**Addendum to the
Coyote Point Recreation Area Shoreline and
Promenade Improvement Project IS/MND
Eastern Promenade Rejuvenation Project**

State Clearinghouse #2009052096

March 2016

**San Mateo County
Parks Department**

**COYOTE POINT RECREATION AREA
 EASTERN PROMENADE REJUVENATION PROJECT
 SITE PLAN**
 CITY OF SAN MATEO SAN MATEO COUNTY CALIFORNIA

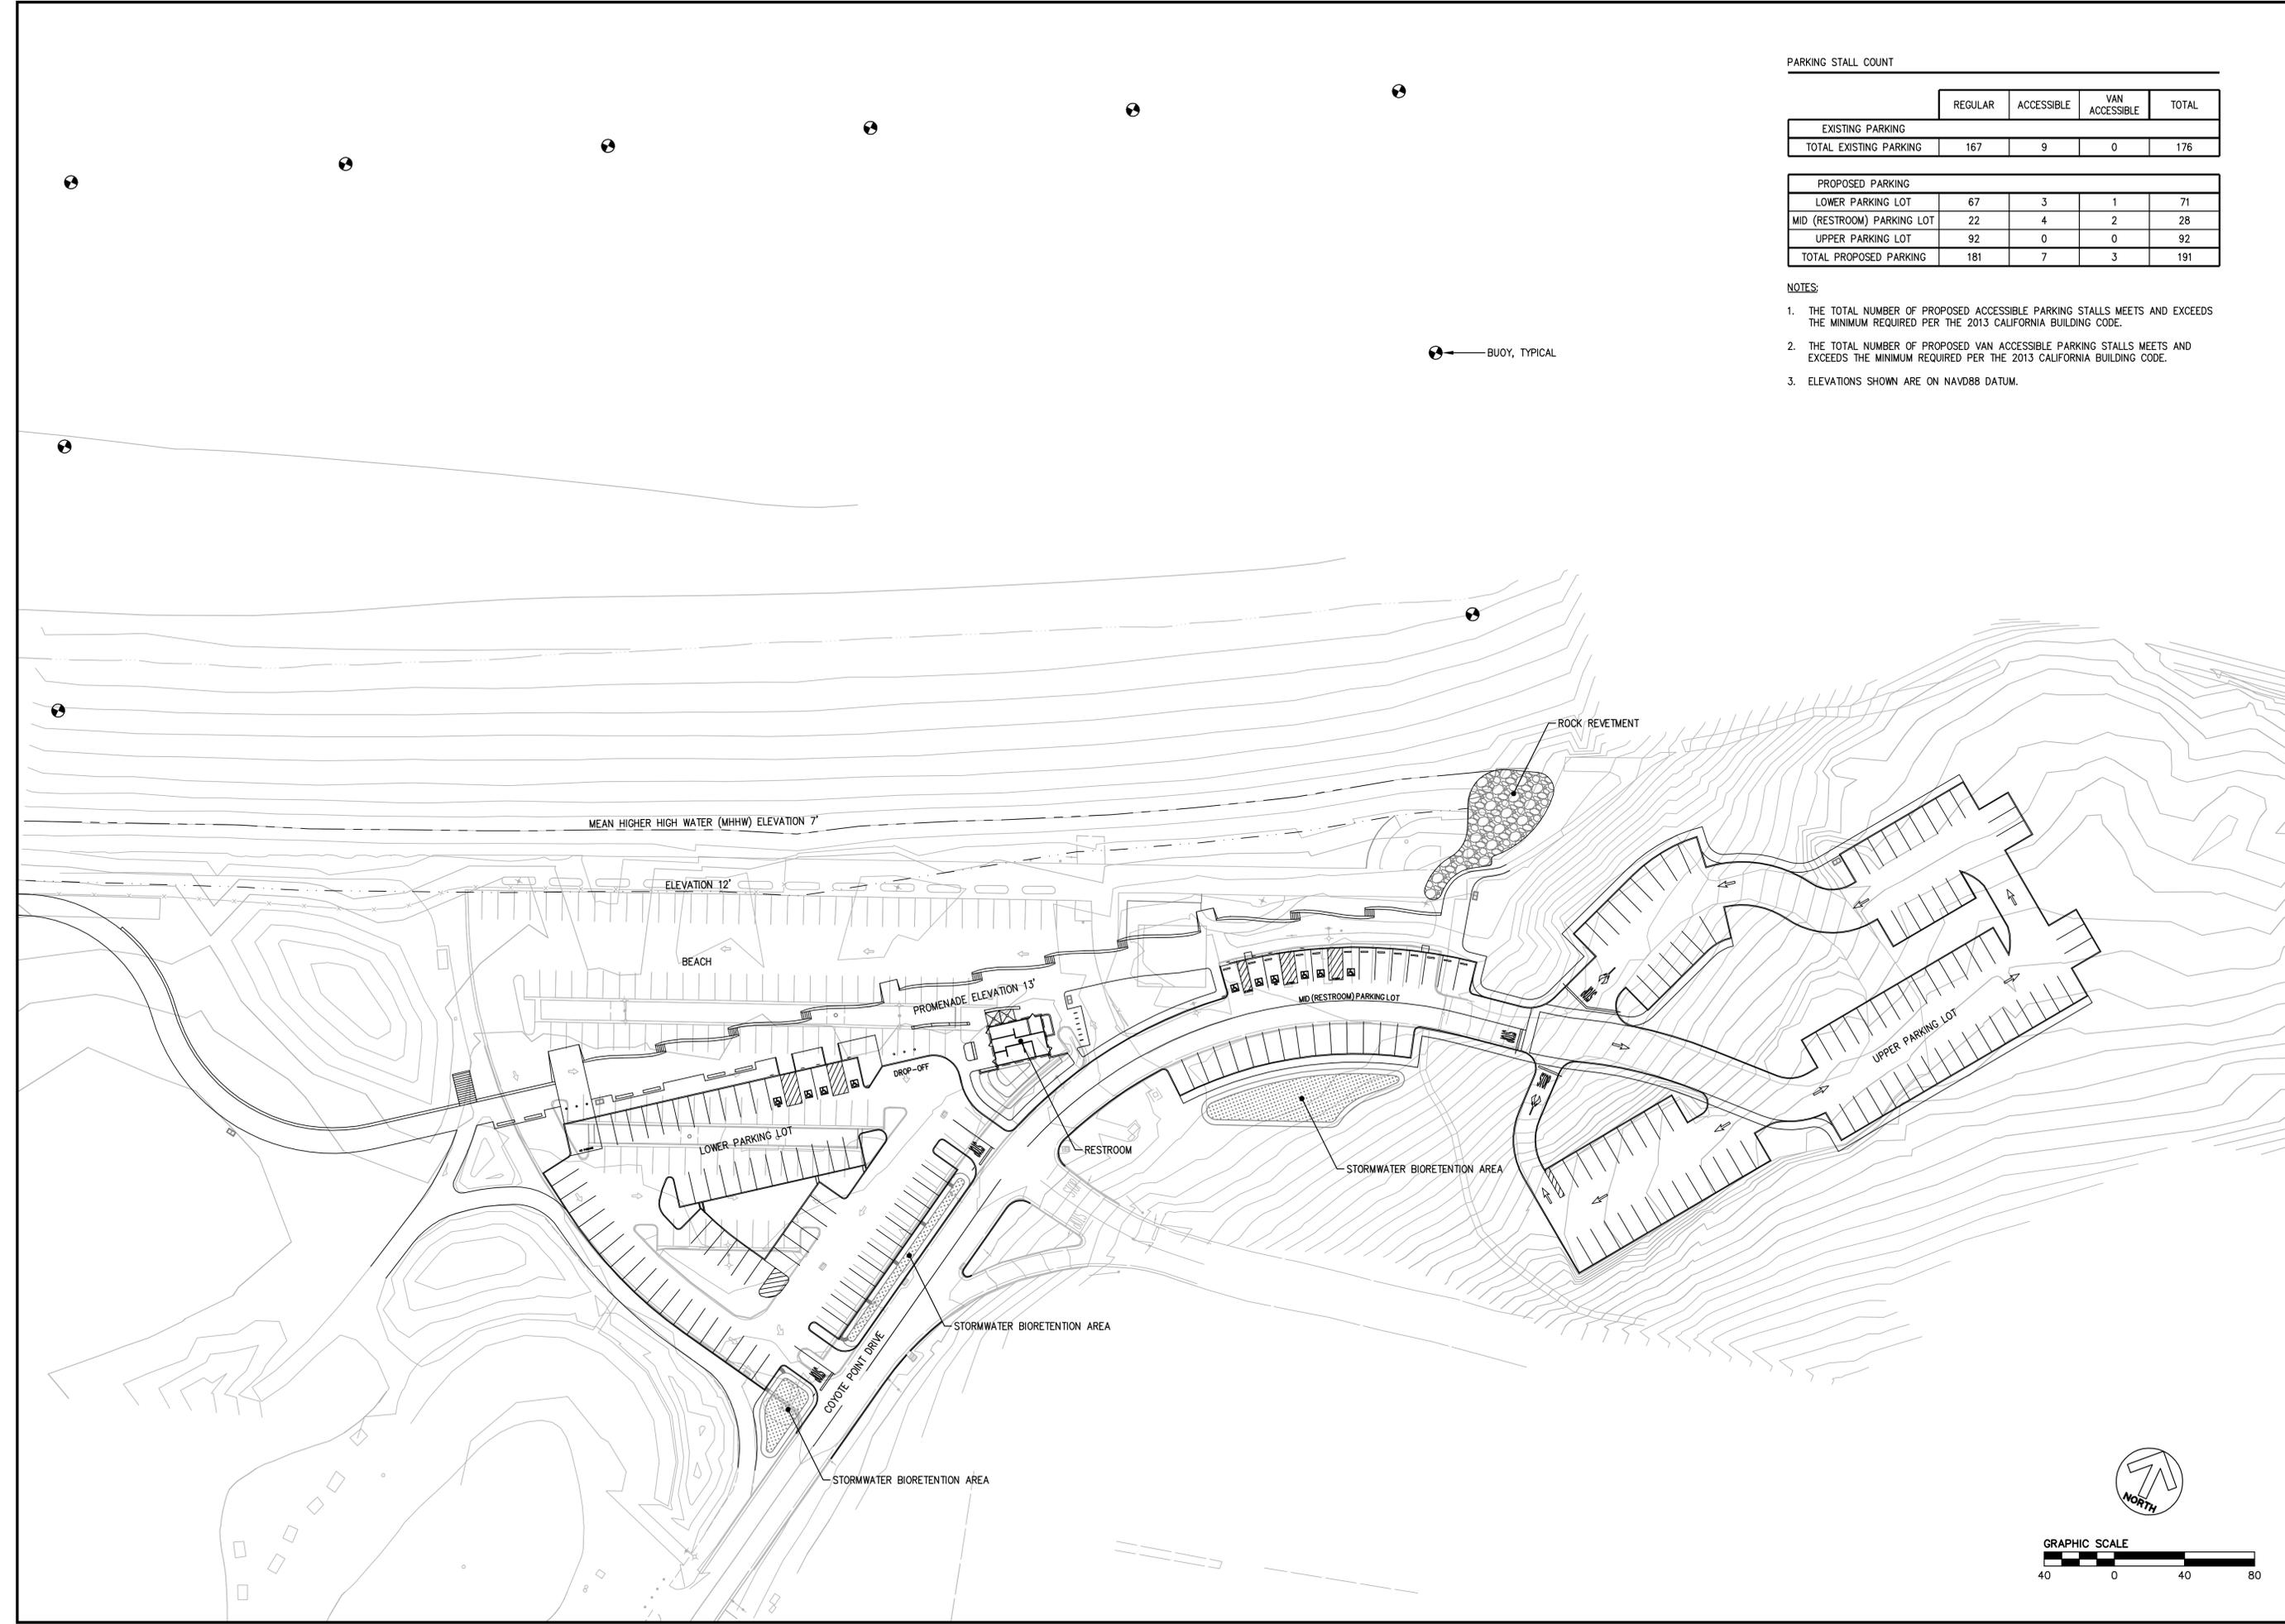
An overview of the primary differences between the previous project, the Coyote Point Recreation Area Shoreline and Promenade Improvement project, which was adopted by the County in 2009 and the revised Eastern Promenade Rejuvenation project under current consideration is presented in Table 1. The original Coyote Point Shoreline and Promenade Improvement project proposed improvements to two distinct areas; the eastern and western areas. The western improvements were completed in 2013 and the remaining improvements under consideration are for the eastern area. These remaining improvements include creation of a crenulate-shaped bay, reconfigured/reconstructed and new parking areas, beach area, completing the pedestrian path network, landscape plantings and irrigation, grading and surface drainage of all planted areas, pedestrian pavements and walls, installation of a prefabricated restroom building, installation of site furniture including benches, bollards, fences, bike racks, trash receptacles and signage and the removal of the remnants of old wooden piers at the water's edge.

The general improvements proposed for the eastern promenade area are largely the same as those that were originally proposed, however, the methods to implement the improvements have been revised to reduce aquatic impacts and account for anticipated sea level rise. The Eastern Promenade Rejuvenation project proposes less earthwork (cut/fill and import/export amounts) than the formerly proposed project (Figure 2). In addition, the previous IS/MND identified several areas that could provide the additional parking required to off-set the loss of parking incurred by the project. However none of these previously identified parking areas is currently proposed to provide parking; instead a new parking area, located just to the east of the eastern promenade improvements in a sloped area containing many mature eucalyptus and other trees is proposed to provide the needed parking (Figure 3).
